### **REMARKS/ARGUMENTS**

#### ***Objection to the Drawings under 37 CFR § 1.84 (p) (5)***

FIG. 1

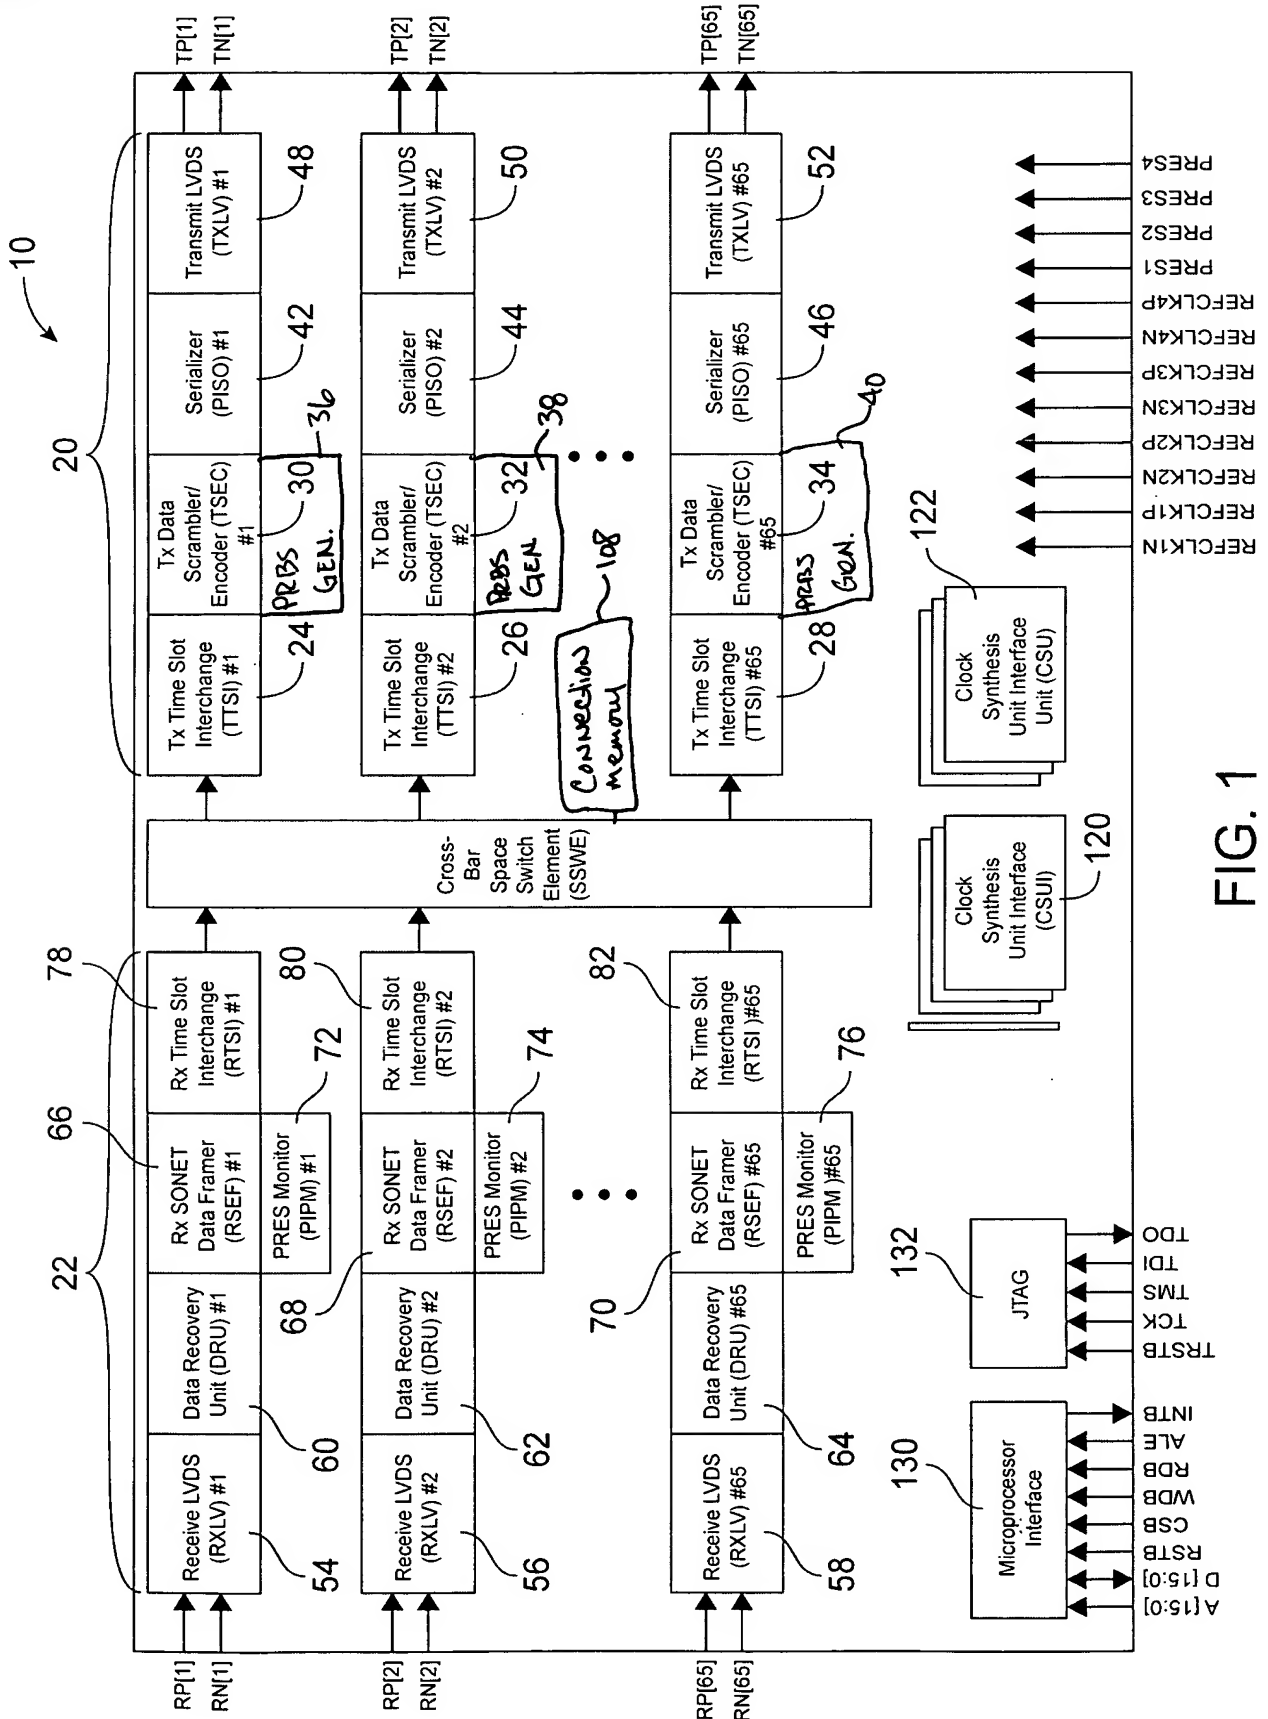
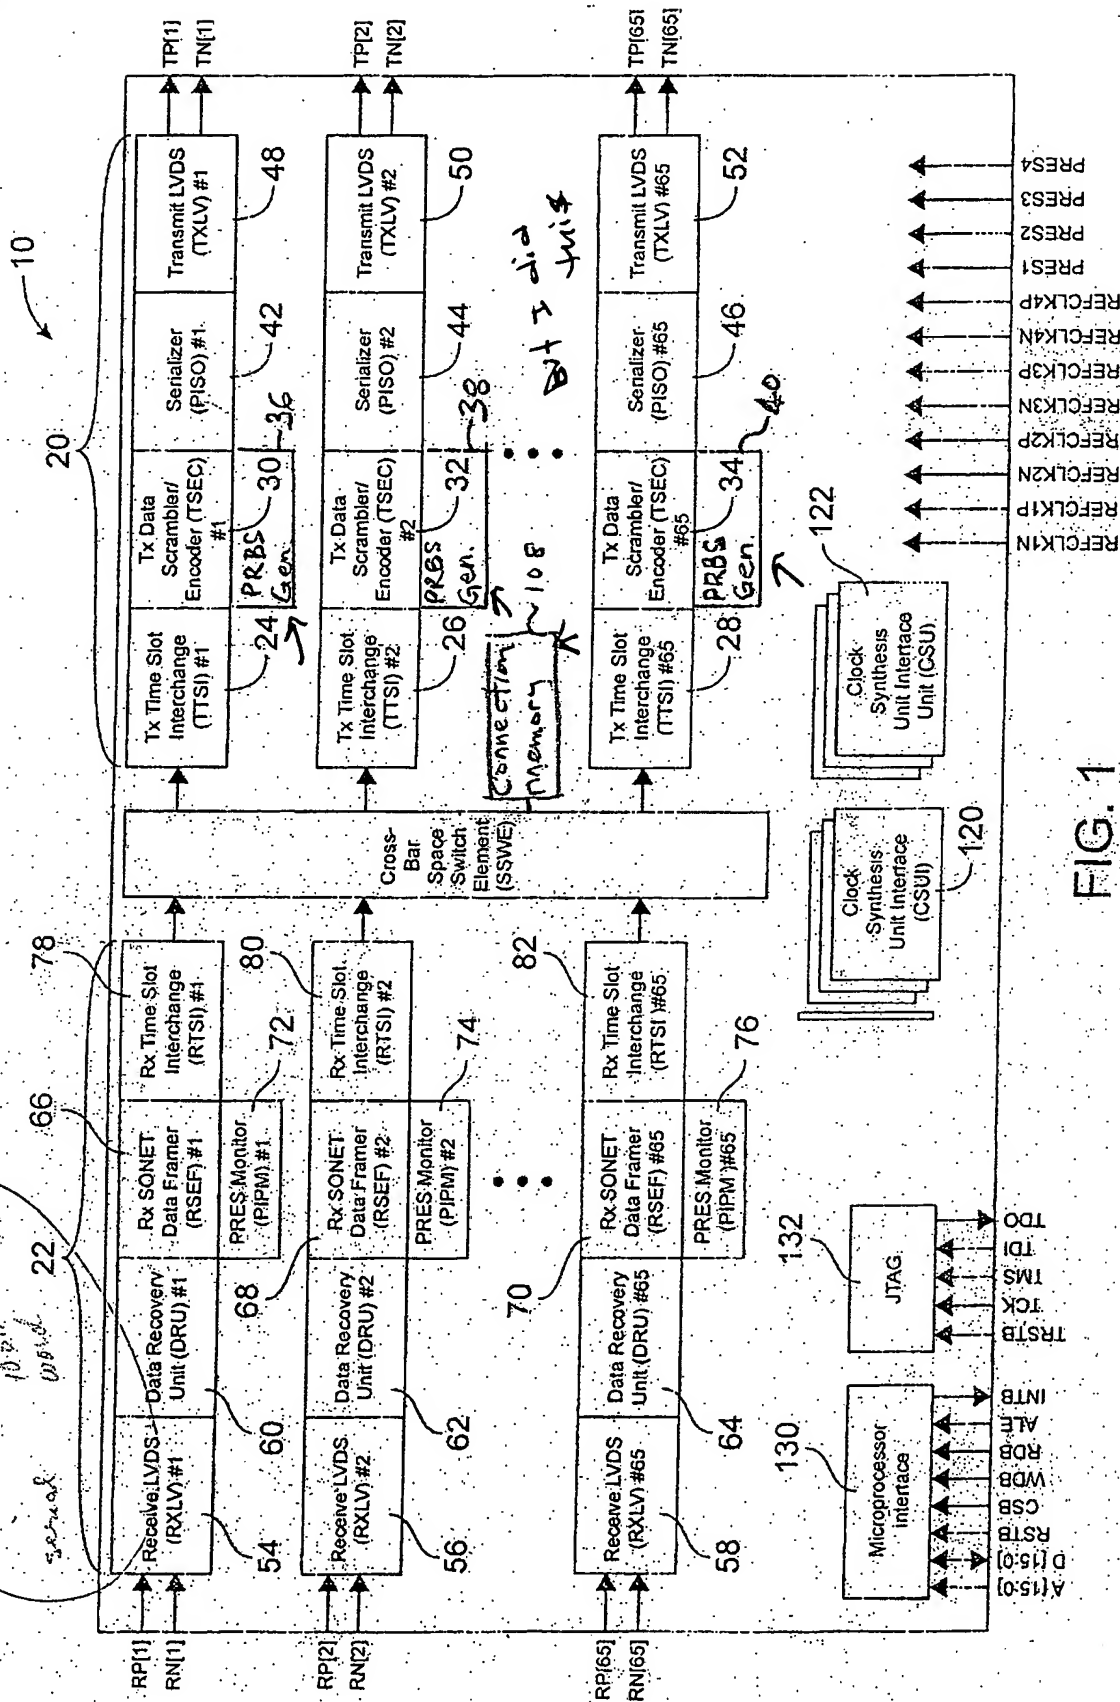
The Examiner has objected to the drawings because they are lacking reference numbers mentioned in the description. In response applicants submit replacement drawings herewith.

Figure 1 of the drawings has been corrected to show the missing reference numbers. For 36, 38, 40 and 108, elements have been added. These elements are inferred by the associated description.
